# STAFF REPORT

RE: 1618 N. Roosevelt Blvd #TP2022-0012  
(Final Landscape Plan Review)

FROM: Karen DeMaria, City of Key West Urban Forestry Manager

**RE: 1618 North Roosevelt Blvd (Landscape Sec 108 Review)**

IRR-01

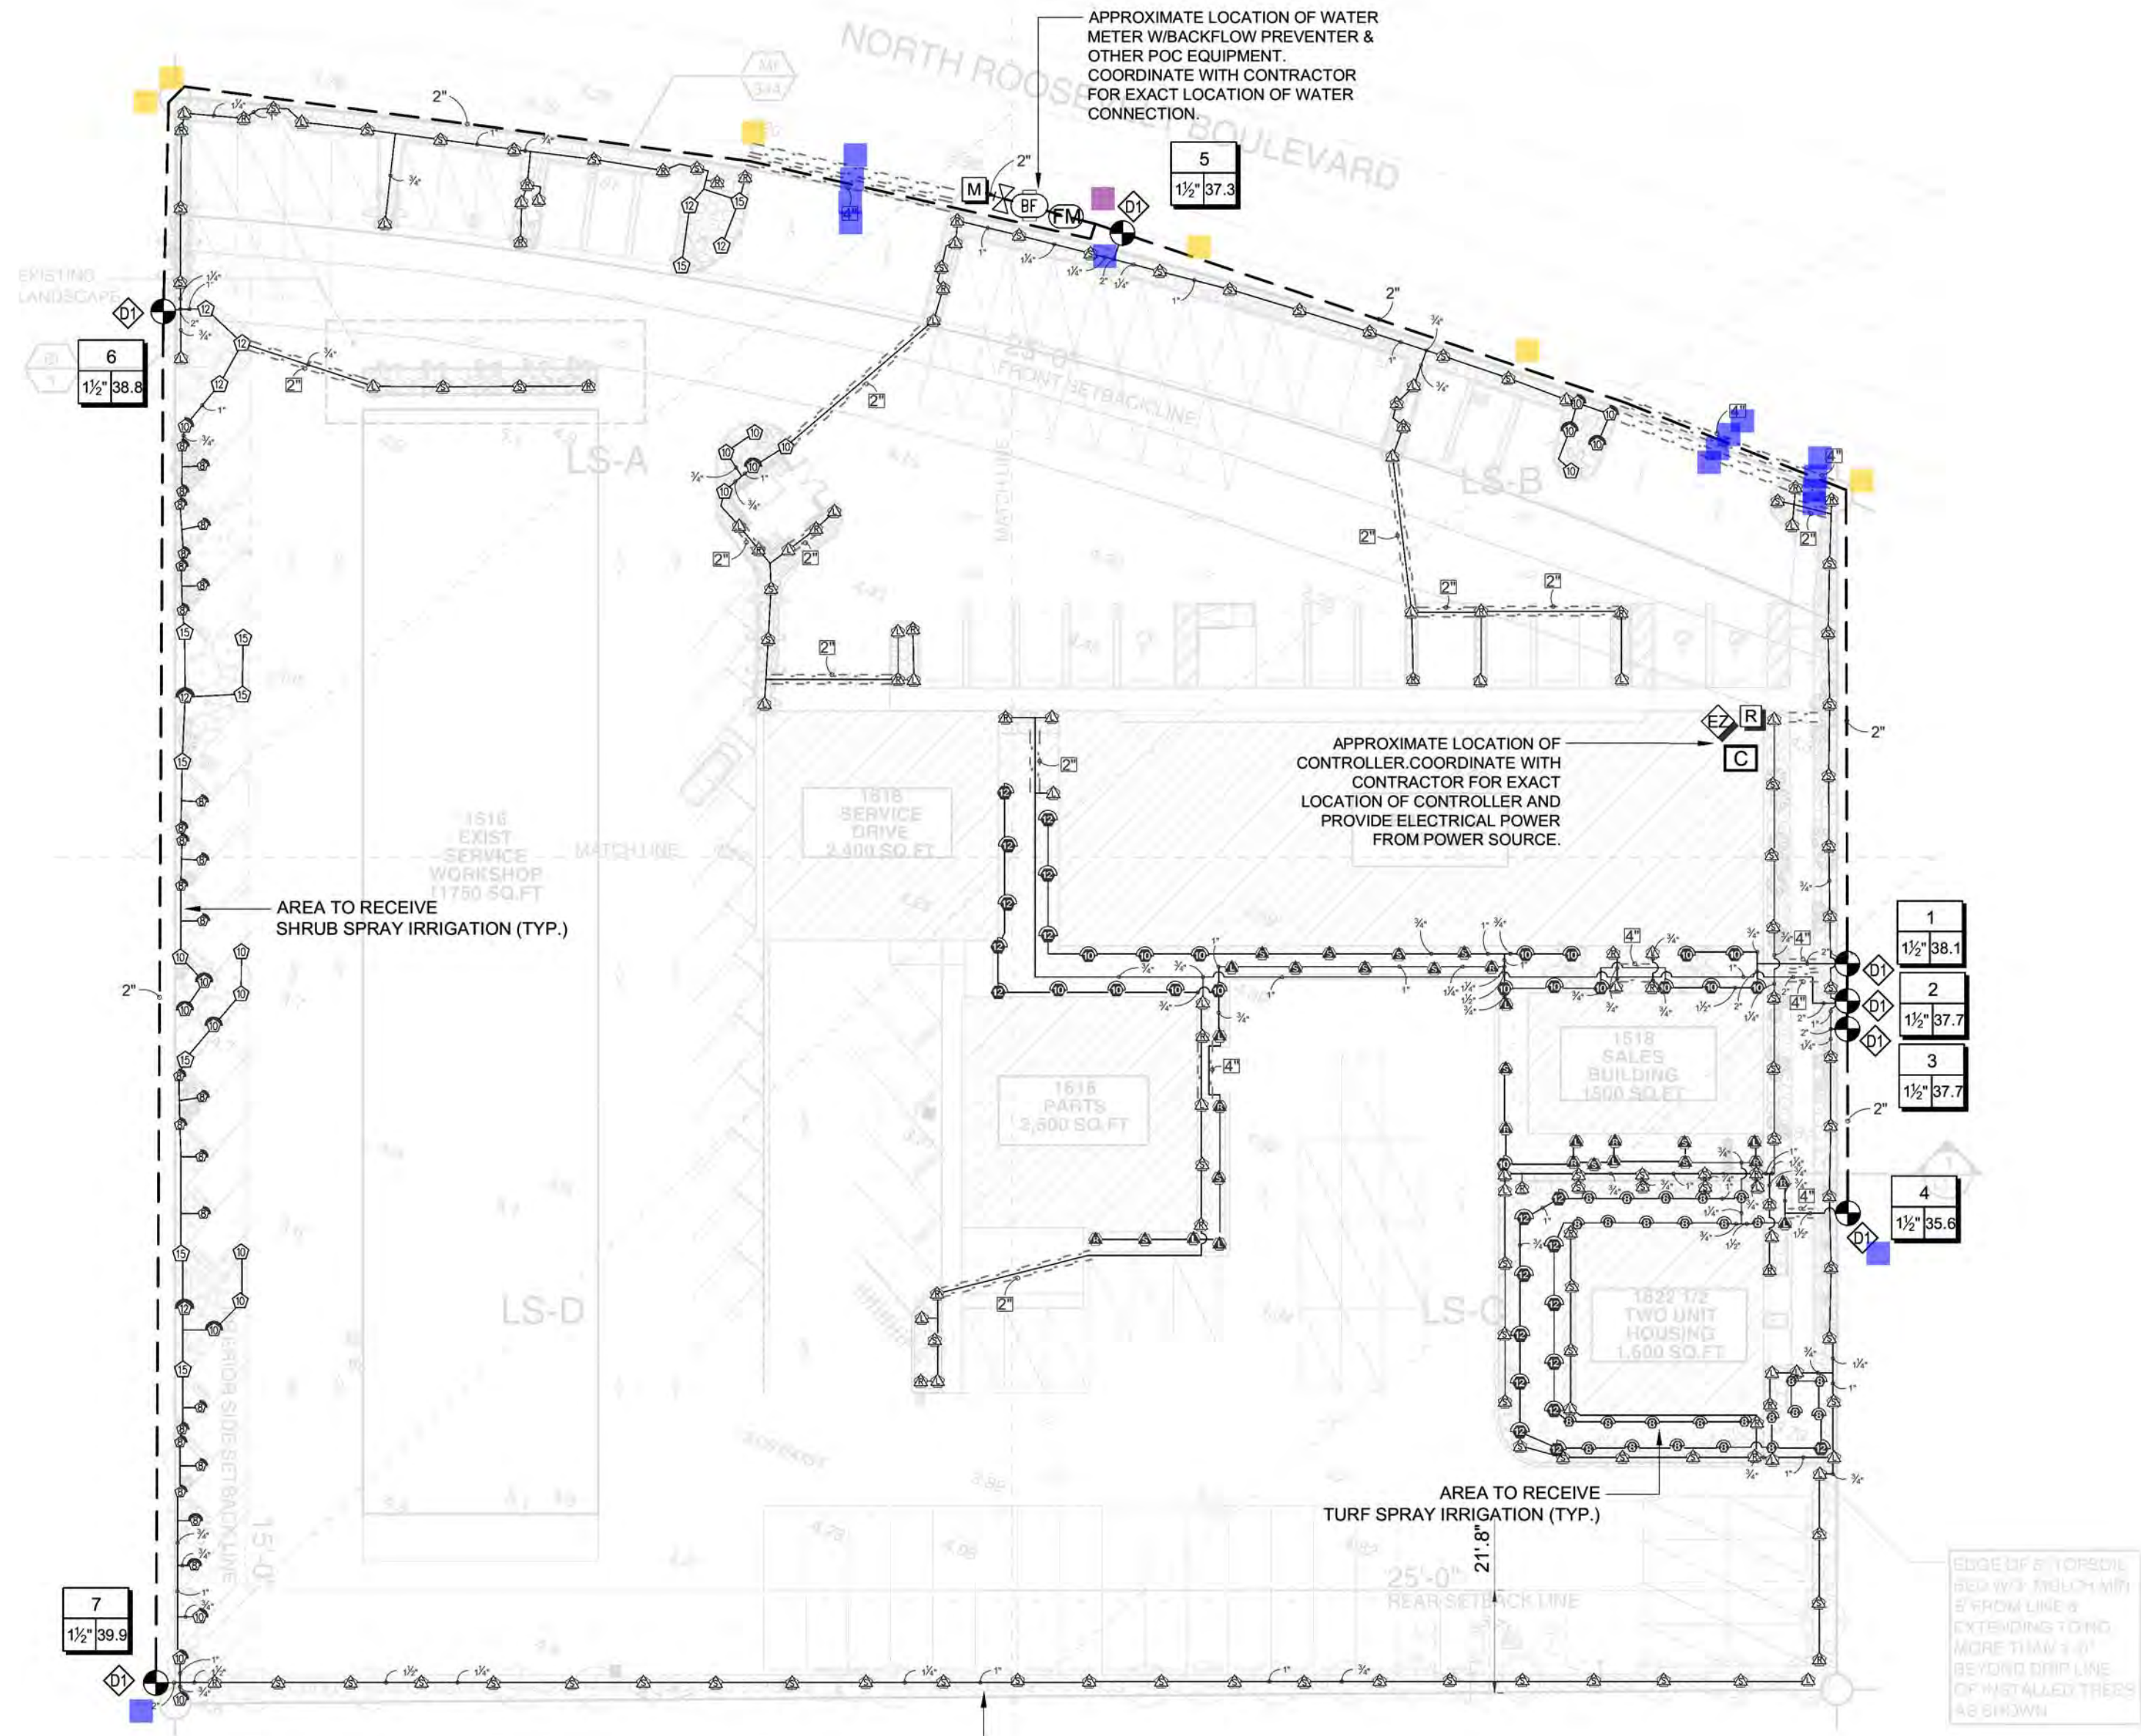
1. Sec 108-243: A landscape plan and a tree protection plan has been submitted. An irrigation plan as per Sec 108-515, has not been submitted.
2. Sec 108-289: The property is an existing, car dealership (disturbed uplands-commercial). The project will not be removing any regulated trees. Regulated palms are to be transplanted on the property.

16. Sec 108-515: Irrigation plan required. An irrigation plan has not been submitted. A note on the landscape plans states; "all areas to be irrigated w/drip irrigation only system (by others) to be included in permit." **A condition of the approval is needed.**

1. Due to the rush review of the submitted landscape plan, final approval of a corrected and updated landscape plan is required from the Tree Commission to include additional plantings, as requested by the Planning Director, and Urban Forestry Manager.
2. An irrigation plan is required prior to placement on City Commission agenda.
3. A landscape maintenance plan and palm transplantation plan is required.

LS1.0

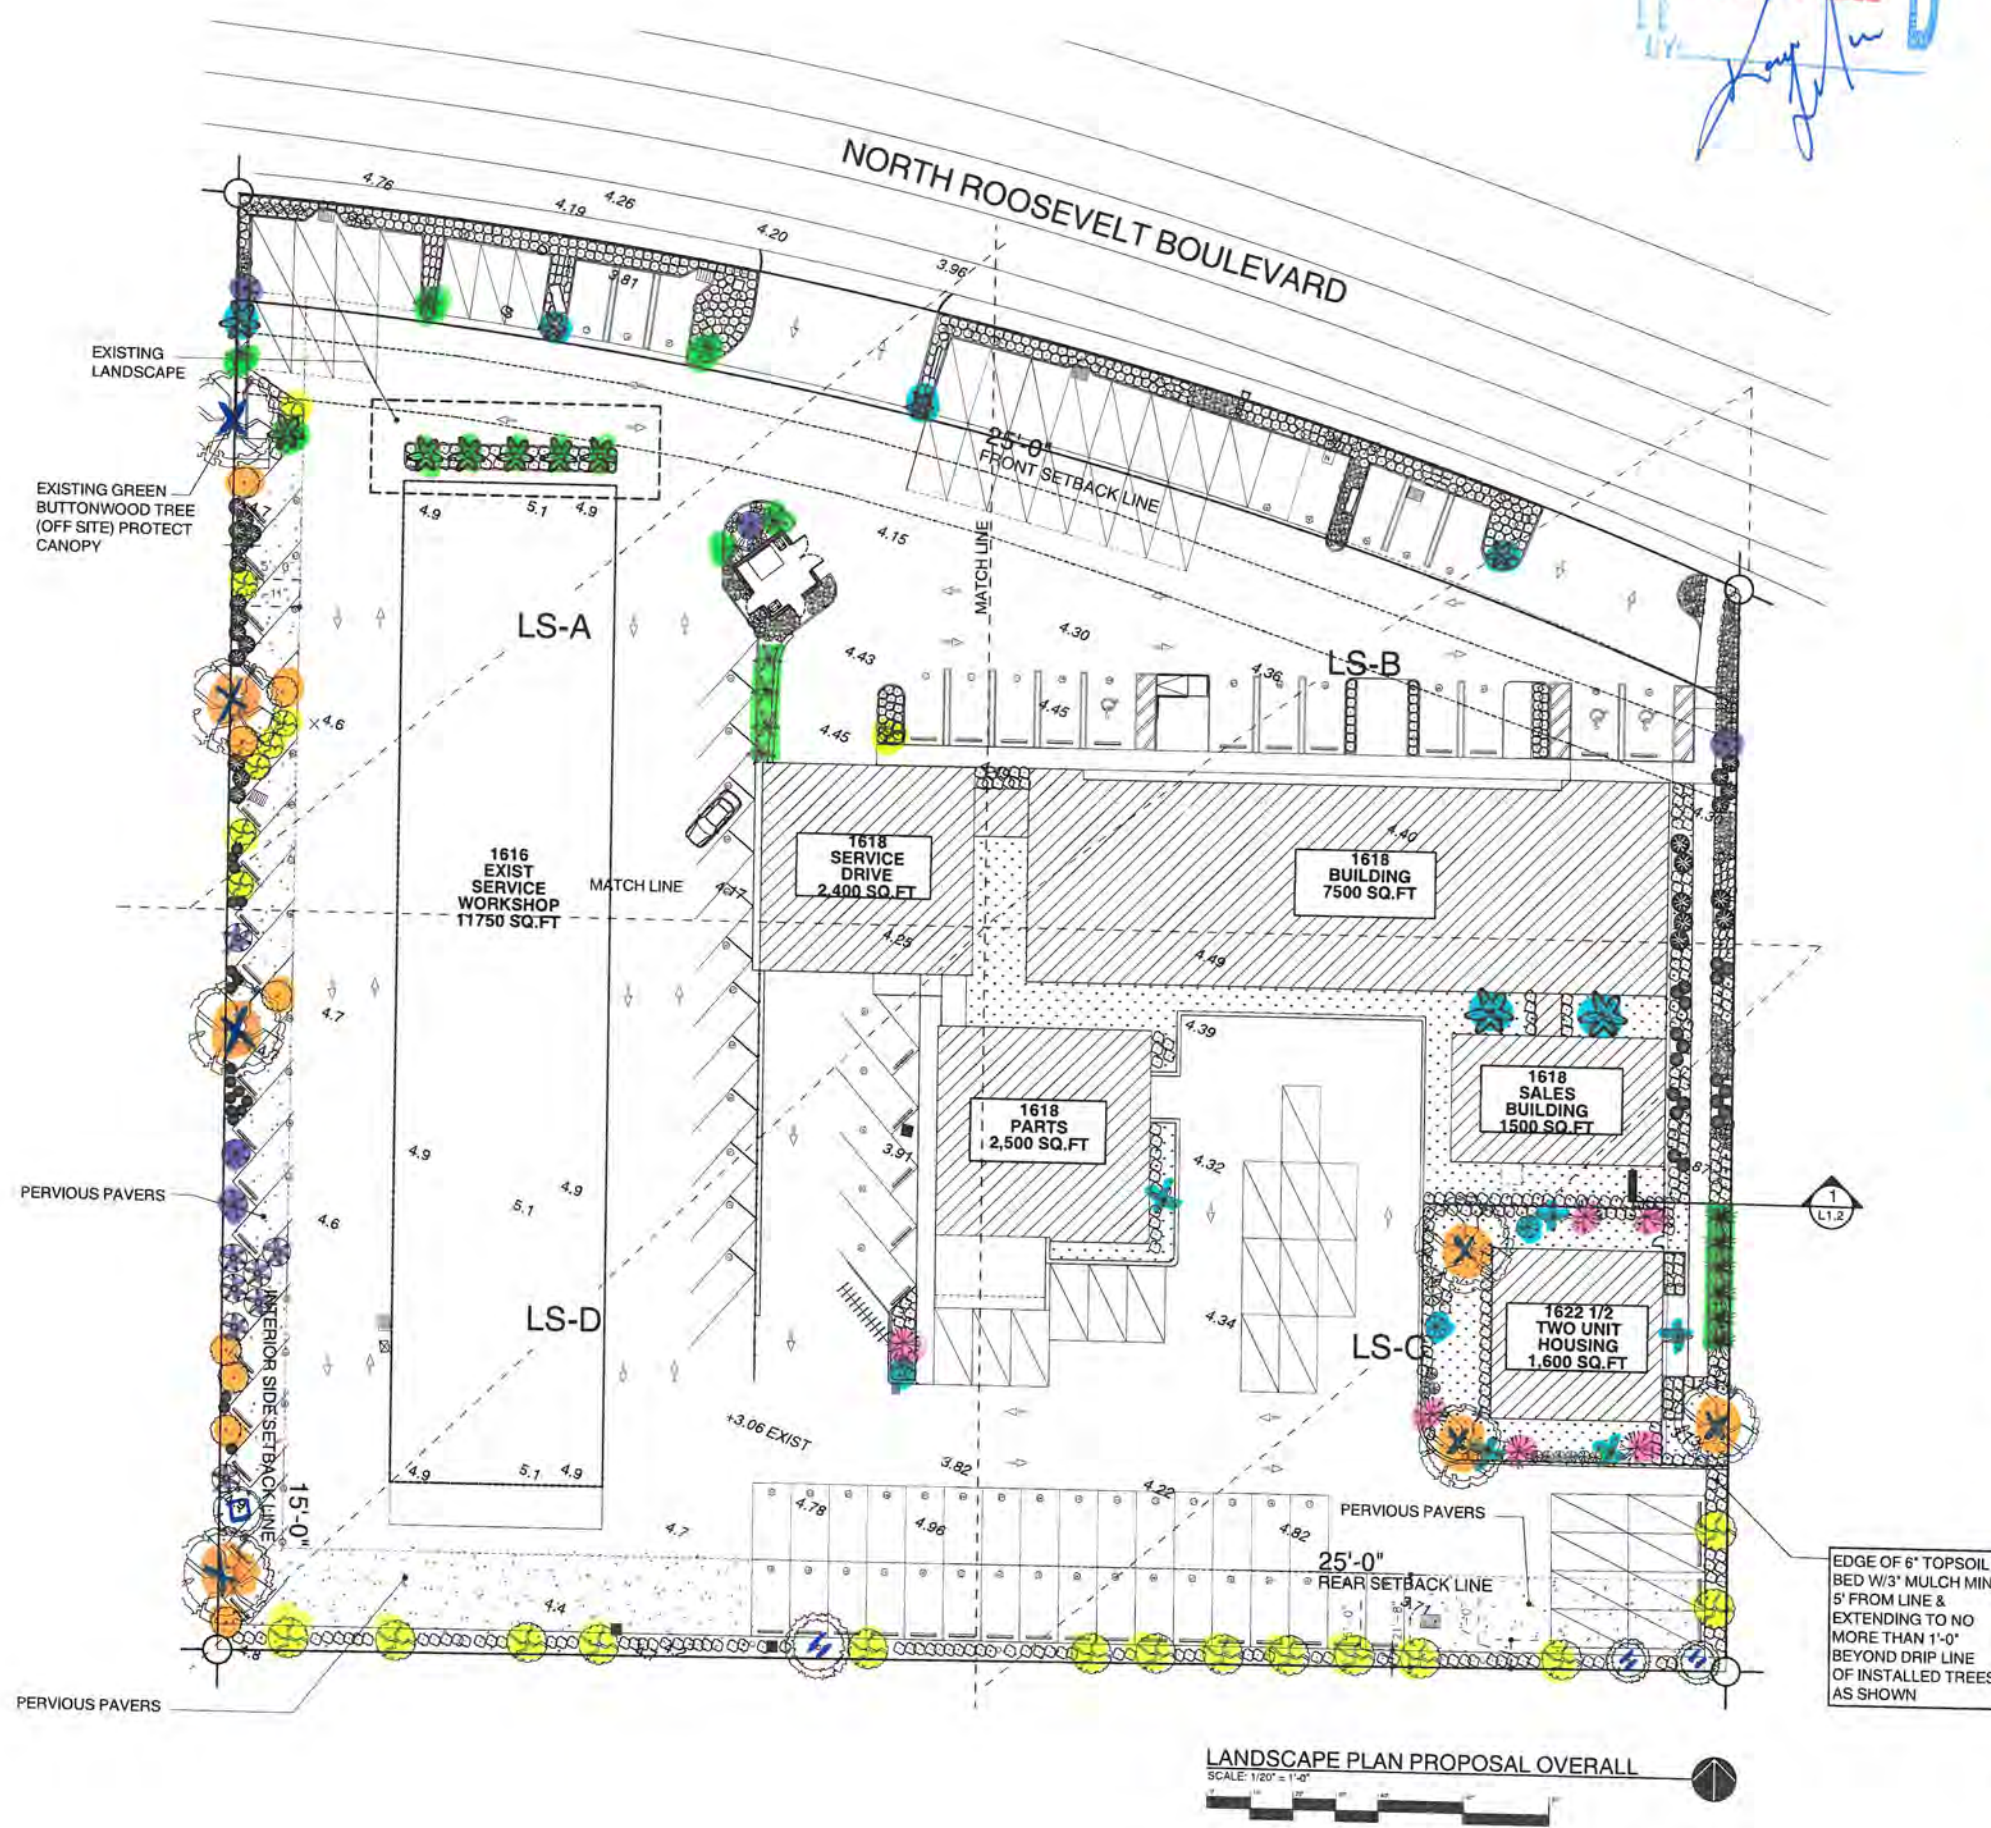
The property is an existing car dealership/auto repair facility that is being redeveloped. The Final Landscape Plan will enhance the existing area and includes additional trees around the property line buffer areas and around the two new residential units. Nine existing Royal Palms and (6) young Bismarkia palms will be transplanted to other areas of the property. The new landscaping is 70% native vegetation. An irrigation and landscape maintenance plan has been submitted. A transplantation plan must be submitted prior to issuance of any building permits.
